## Attachment 9 – Assessment of compliance with Shell Cove Precinct D Urban Design Guidelines

### Shell Cove Precinct D Urban Design Guidelines

Figure 9.3 - eastern elevation building C

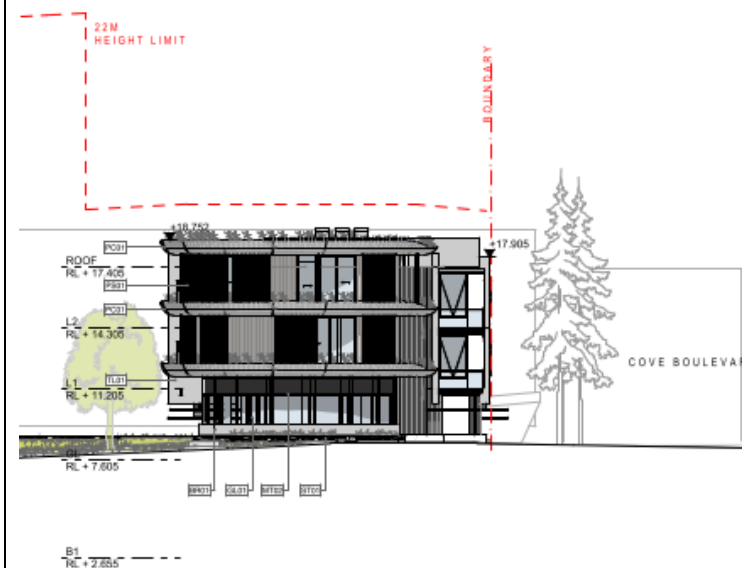
Building C will front Cove Boulevard (Road 10) and will be the gateway development at the entrance to the Town Centre precinct. The building will be suitable scale to balance the existing development that fronts Cove Boulevard with suitable architectural design to add interest to this area. The curved elevation will be unique to this lot utilizing materials and finishes that reflect the coastal nature of the location. Snip of relevant elevation included in figure 9.3 below.
